**ADDISON AIRPORT
BUILDING REPORT**

Facility Information: Facility Name: 4666 Glenn Curtiss Drive
Facility Contact: Lisa Pyles Contact Phone: 972-450-2878

Accessology Inspector Information:
Inspector: Karen Jackson Date: May 3, 2017
Email: Kjackson@accessology.com

Violation 1 - Four parking spaces serve this building, none of which are accessible.

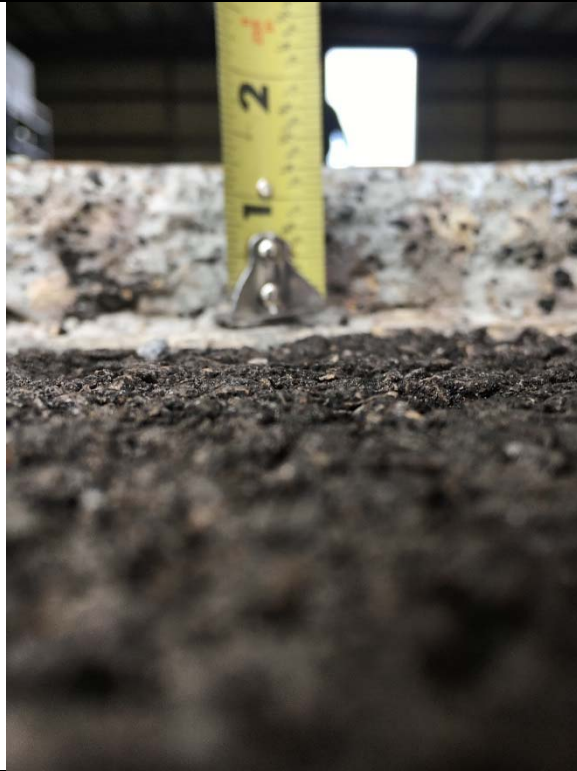
Violation #1: Four parking spaces serve this building, none of which are accessible.

Possible Solutions: Provide one van accessible parking space, an access aisle and compliant signage.
